REVISIONS:

#21-18 Montreal and Quebec 205 Quebec Street Victoria, BC

Rezoning/DP Resubmission

Revision Set 25.02.13

sheet title Site Plan

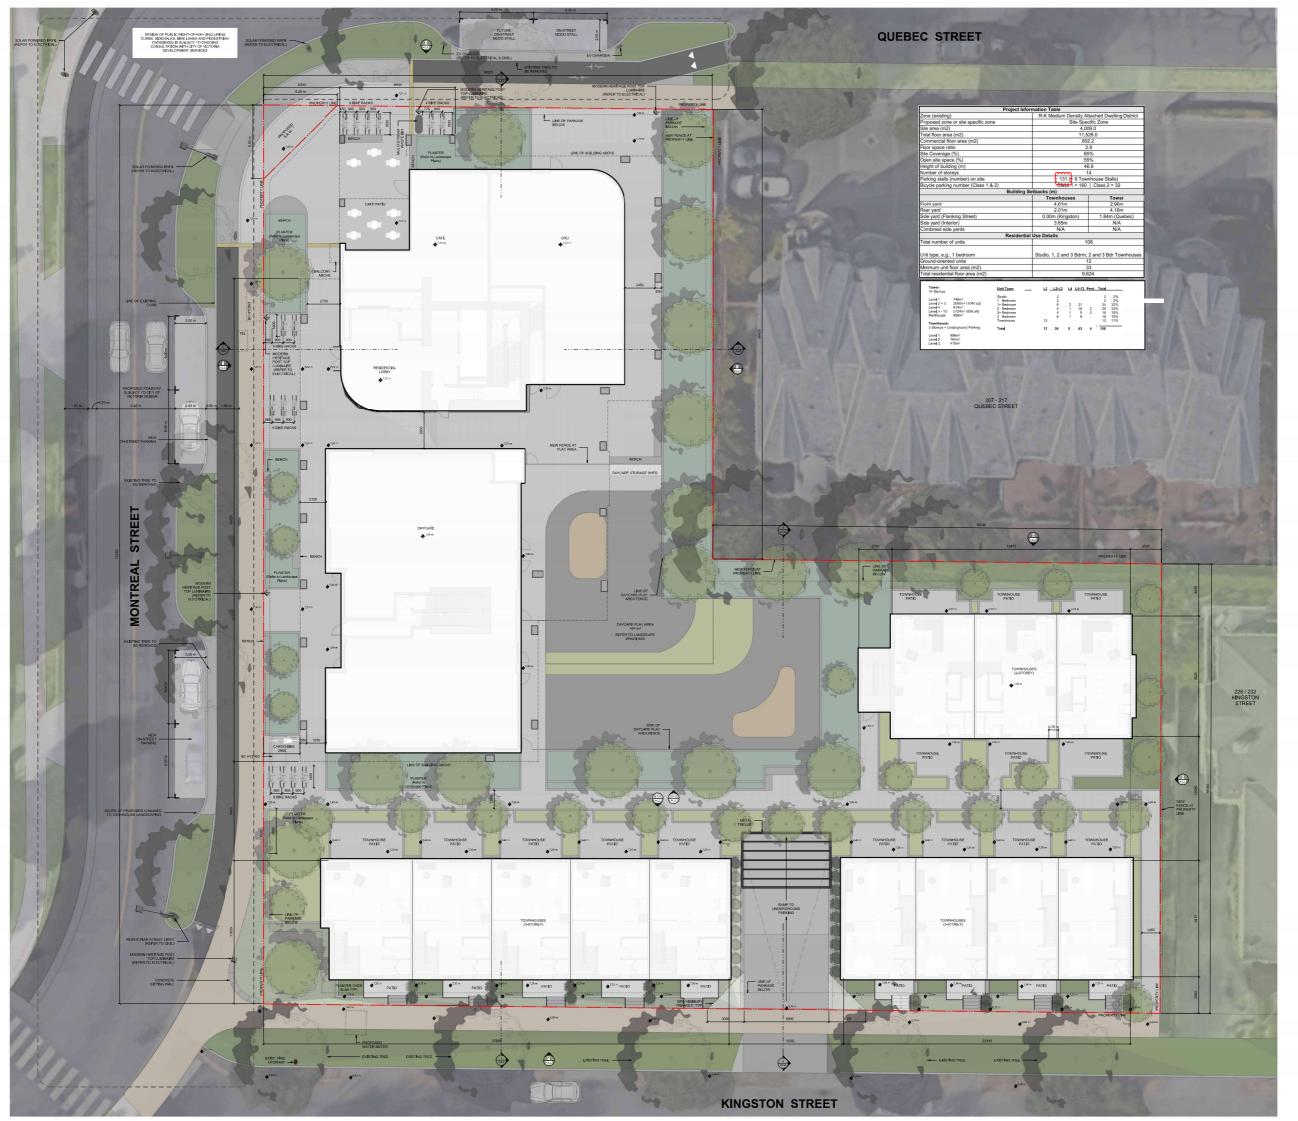
A1.1 SITE PLAN
- ADJUSTED VEHICLE STALL COUNT ON PROJECT DATA

REVISION DESCRIPTION:
PARKADE STRUCTURAL COORDINATION HAS
REDUCED THE NUMBER OF STALLS REDUCED
BY ONE.

sheet title P1 Phasing Plan

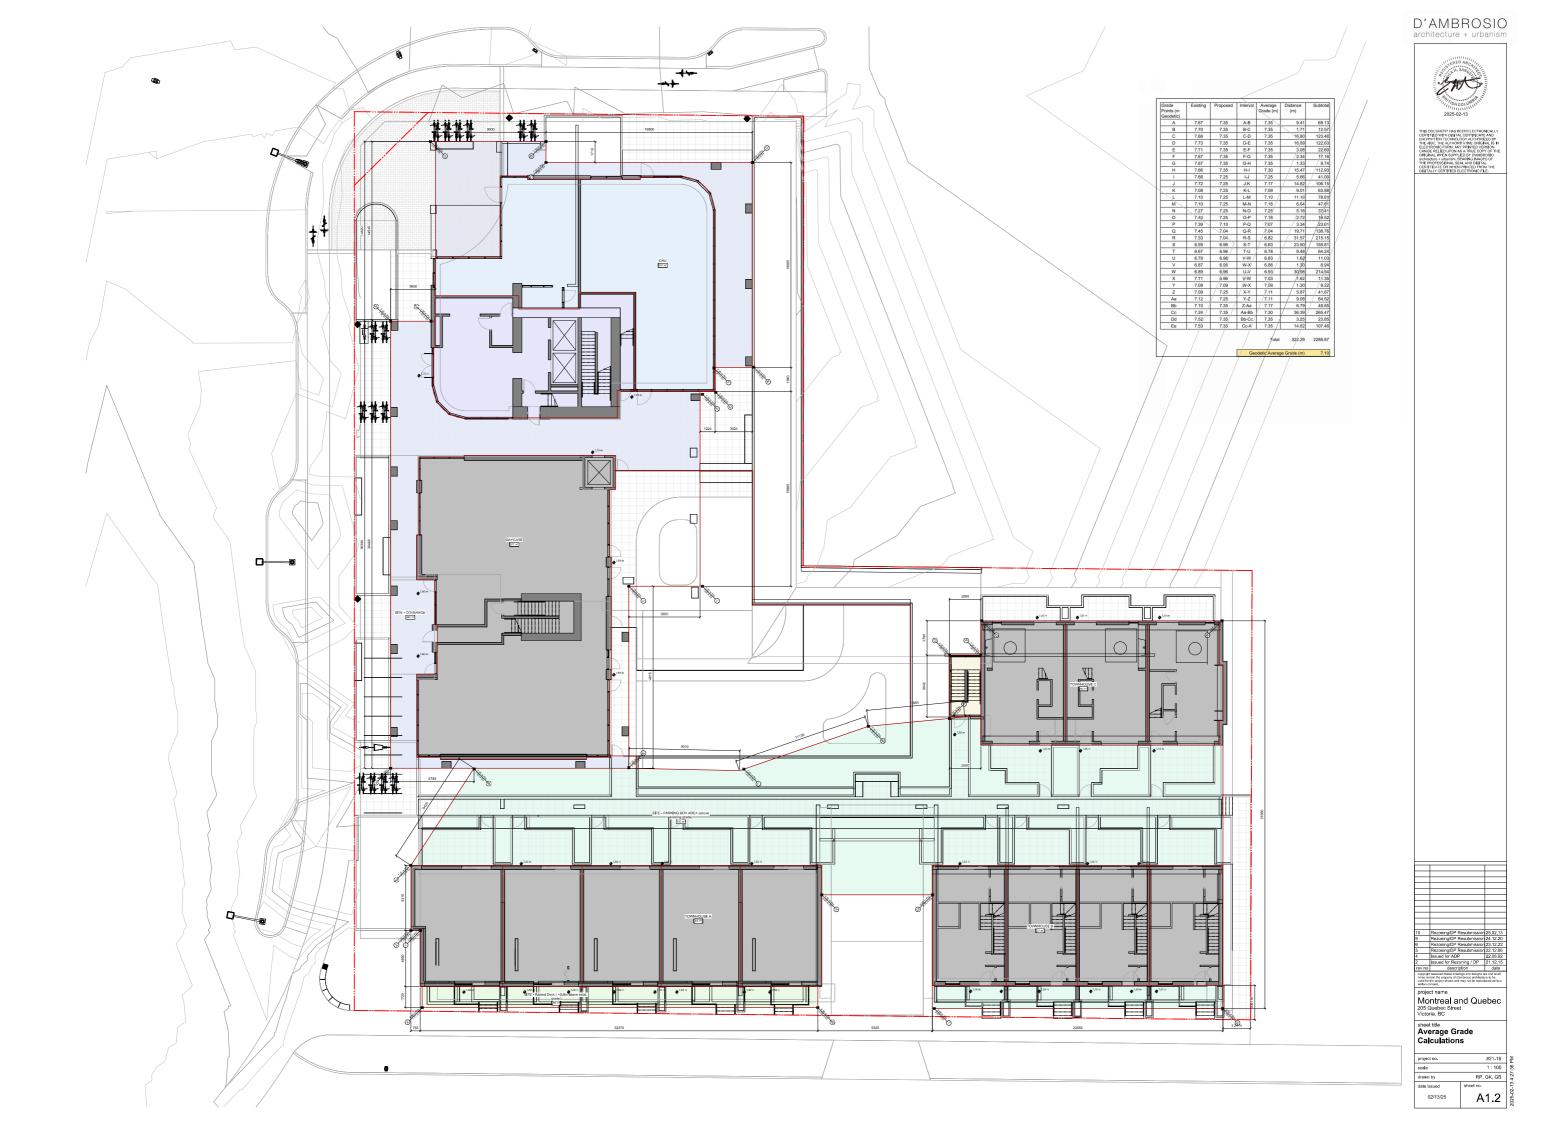
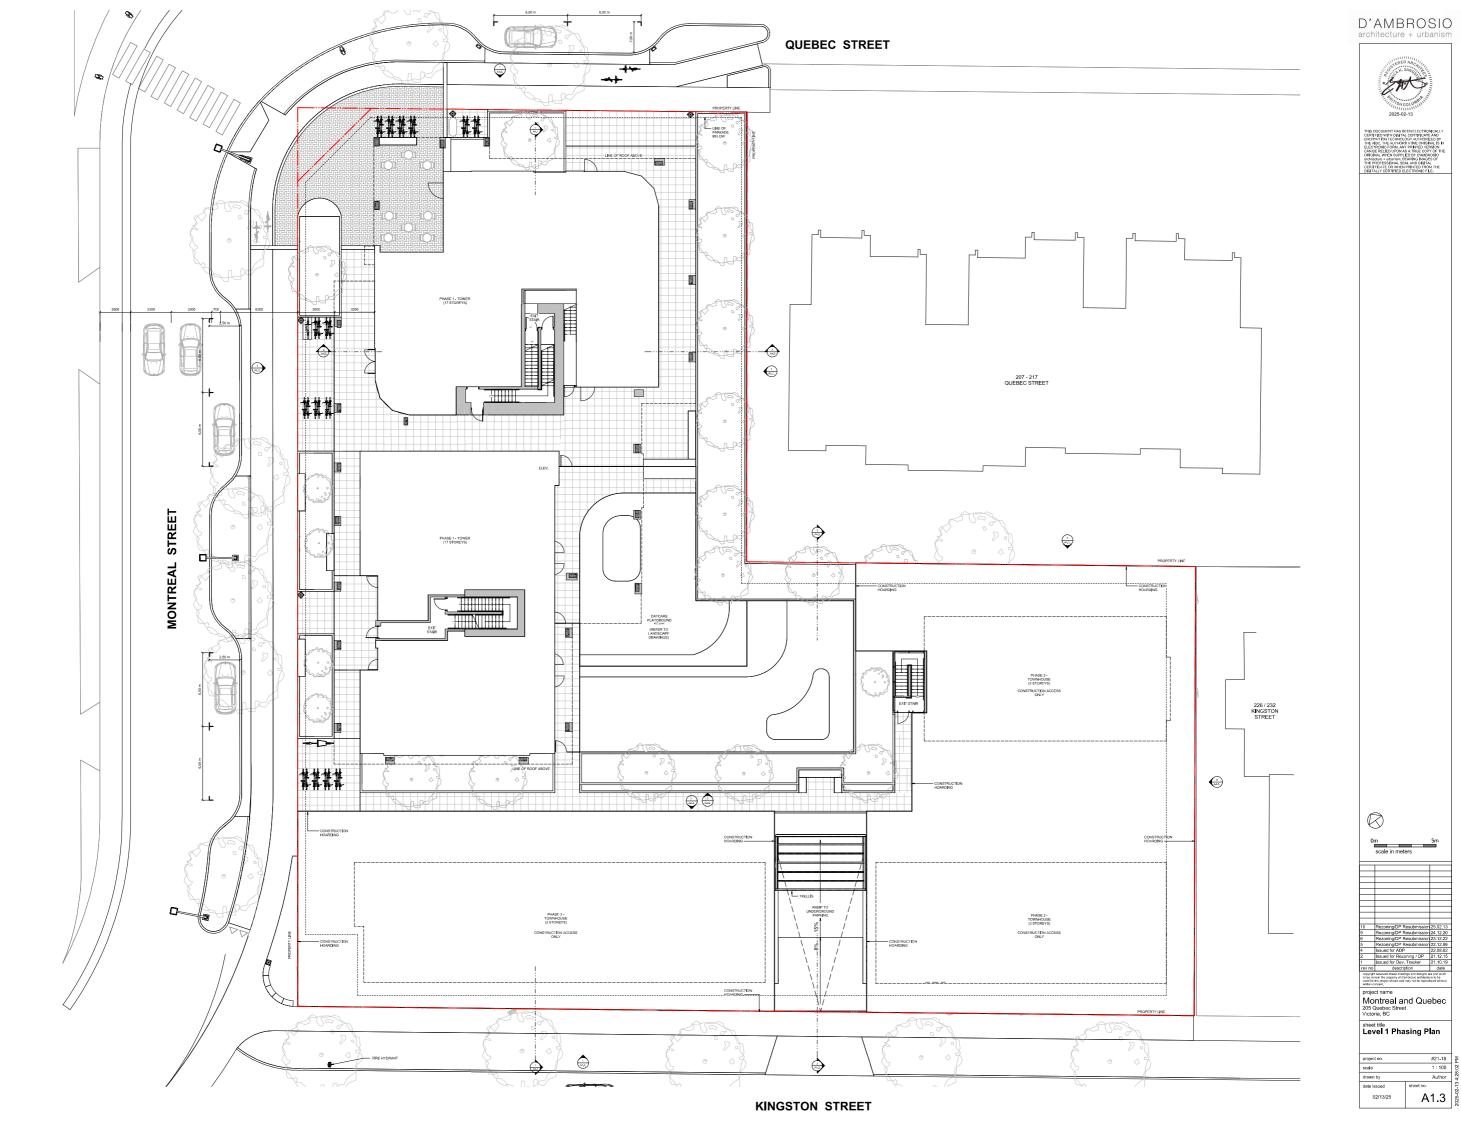
A1.4 P1 PHASING PLAN
- ADJUSTED COLUMN LOCATIONS

sheet title P1 Parking Plan

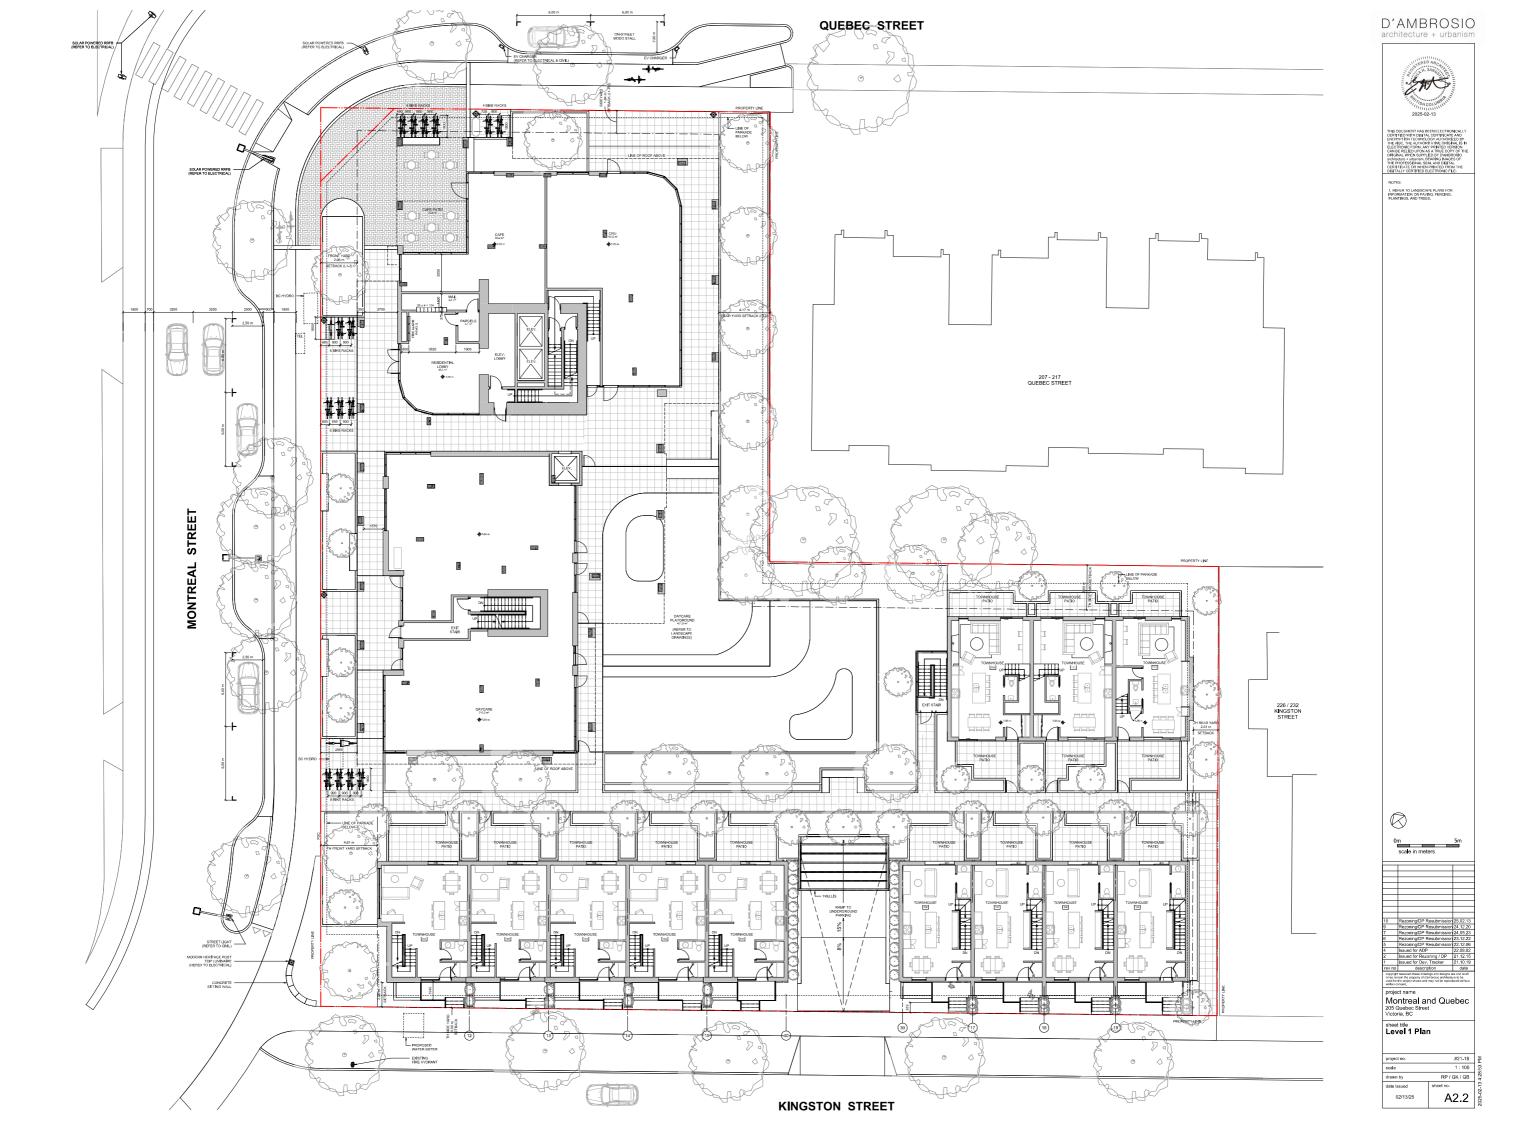
A2.1 P1 PARKING PLAN
- ADJUSTED COLUMN LOCATIONS
- PARKING DATA UPDATES
